IN THE MATTER OF:
SUBCOMMITTEE MEETING
OR
PEBBLE SPRINGS

Portland, Oregon
Place -
28 October 1977
Date -

ADVISORY COMMITTEE ON REACTOR SAFEGUARDS

PEBBLE SPRINGS

FIGURE 1
 ASME CODE SECTION III APPENDIX G
 RCS OVERPRESSURE LIMIT

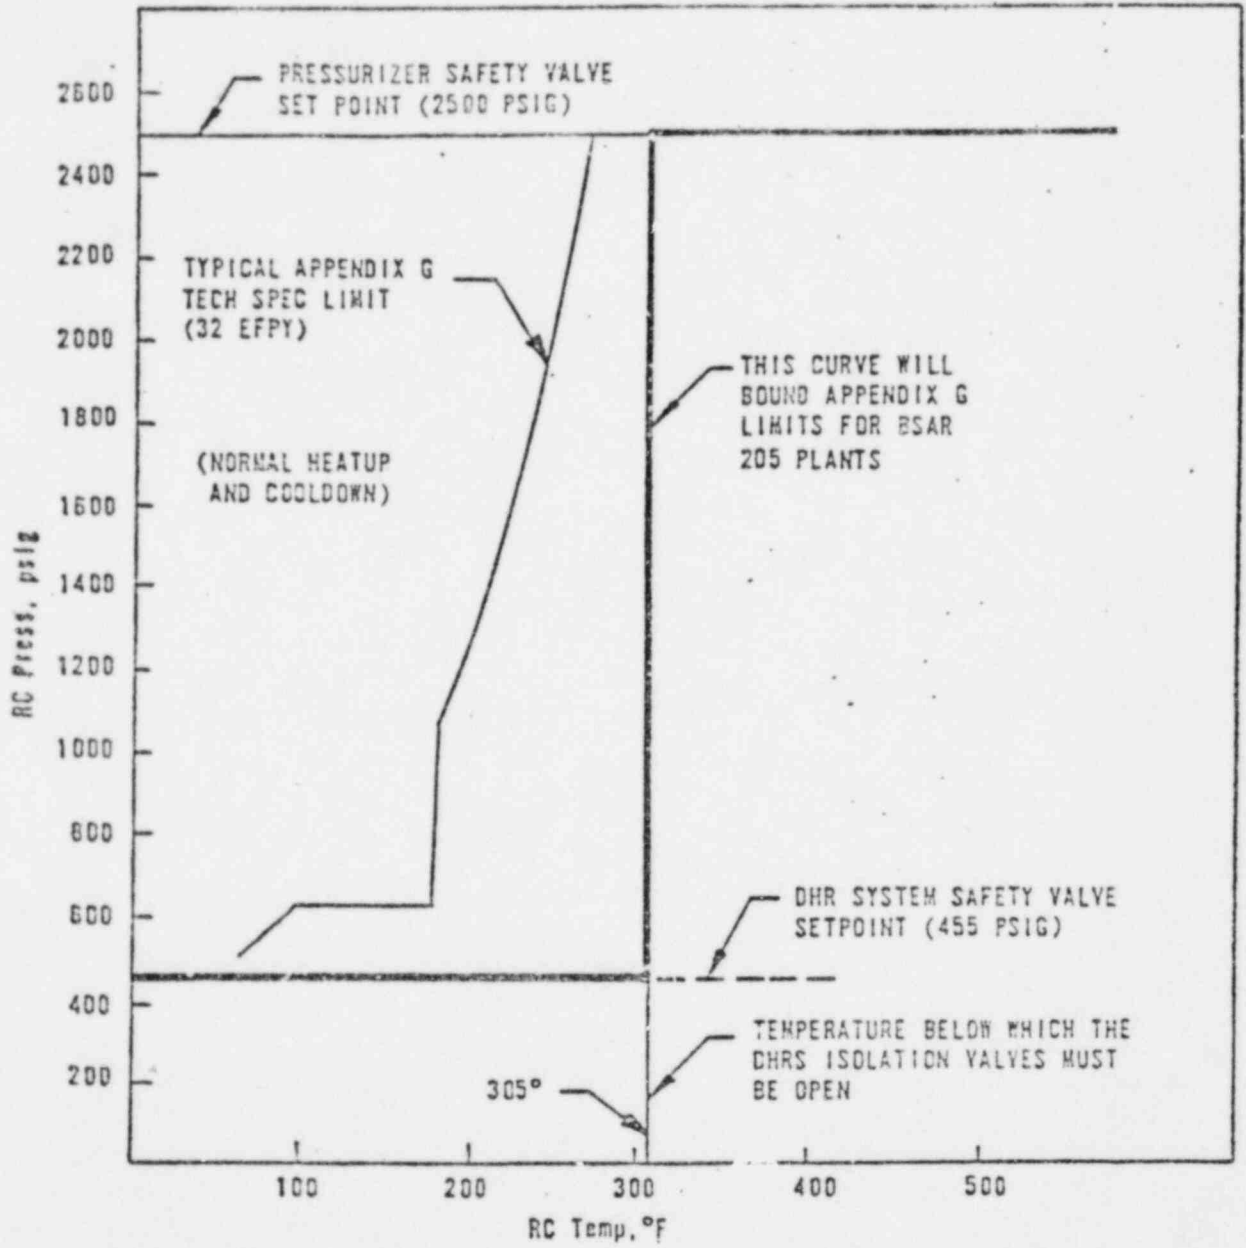
Overpressure Protection at Low Operating Temperatures - The staff is currently developing a position which will provide requirements for the design of a protection system for these events. The applicant must commit to the following minimum criteria prior to issuance of a CP:

Response to Open Item No. 2

Appendix 10 CRF 50 specifies the minimum fracture toughness requirements for ferritic materials of pressure-retaining components of the RCPB. These requirements are provided in the Technical Specifications for normal and test conditions as a pressure limit which varies as a function of reactor coolant temperature and rate of temperature change.

As shown in Figure 1, the pressure limit is relatively low at low reactor coolant temperatures and then increases to higher limits at higher reactor coolant temperatures. The Appendix G limit shown in the figure was determined using the following:

This is a typical limit curve for B&W plants and is applicable to Pebble Springs.

The Appendix G limits are restrictive only at the lower reactor plant temperatures associated with RCS startup and shutdown operations. Worst-case pressure transients that could occur under these conditions were determined to be the following:
